## BOARD OF ZONING APPEALS DIVISION I

| <b>Case Number:</b>           | 2025-DV1-064                                                                                                                                                                                                                                                                                                                                            |
| <b>Property Address:</b>      | 3155 Arbor Street ( <i>approximate address</i> )                                                                                                                                                                                                                                                                                                        |
| <b>Request:</b>               | Variance of Development Standards of the Consolidated Zoning and Subdivision Ordinance to allow for a detached accessory garage within the front yard of Arbor Street (accessory structures must be behind primary buildings), and for a 72-foot wide parking area within the front yard of Arbor Street (maximum 30-foot wide parking area permitted). |

2025DV1064 ; Site Plan (01/07/2026)

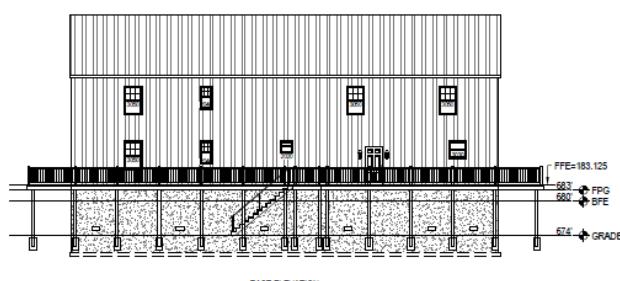
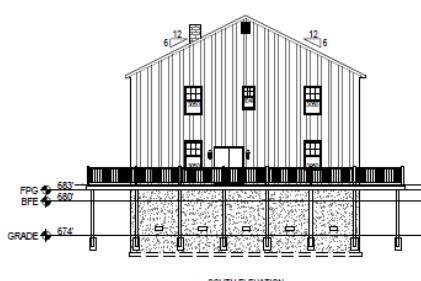
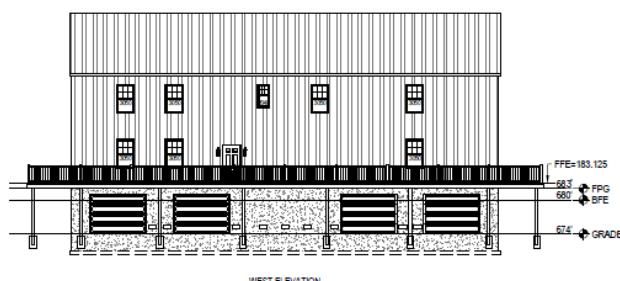
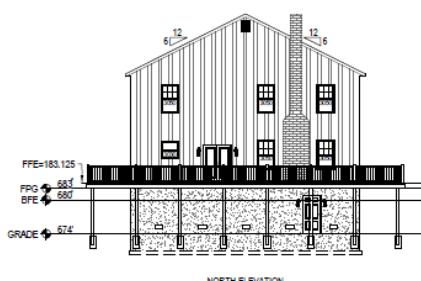
- The applicant is seeking to develop this site with a single-family residence. A flood permit was issued in 2024 to allow for that development with the primary and accessory structure in the locations shown below.

- Two (2) variances of development standards would be required to allow for the proposed design. The first would be to allow for a detached accessory structure within the front yard between the proposed building location and the front property line. The second would be to allow for a parking area width of 72 feet within the front yard of the site (maximum of 30 feet permitted). It appears that no variance would be needed related to the Flood Control Ordinance given the previous issuance of a flood permit, and the applicant has indicated that gravel parking areas would have distinct edge buffering as required by Ordinance.

- Due to site-specific constraints related to the location of the property within the Floodway Fringe and the limited amount of undisturbed soil at the site, the proposed location of the primary structure at the rear of the site would be the only feasible location for development to occur. Staff would note that in addition to there being no feasible way to have an accessory structure placed behind the primary building, the proposed detached garage would be offset to the north from the primary residence in a manner that wouldn't directly impede visual access from Arbor Street (approximating the intent of Infill Housing Guidelines). For these reasons, staff recommends approval of the requested variance for an accessory structure within the front yard.

- However, no such site-specific practical difficulty exists to justify approval of the requested variance for the parking area width of 72 feet. The limitation on front-yard parking area width for residential areas within the Ordinance exists to allow for vibrant front-yard areas primarily defined by green space (echoed within the Environmentally Sensitive overlay guidance from the Comprehensive Plan) while still allowing adequate space for vehicle maneuverability. Placement

of a parking area over twice the maximum amount allowed would run counter to these goals, and may also negatively impact the property within floodway fringe by reducing space for front-yard compensatory storage and drainage retention and resulting in additional areas of mud and chuckholes for the gravel drive. Staff recommends denial of the driveway width variance.

Staff recommends **approval** of the accessory garage request and **denial** of the parking area request.
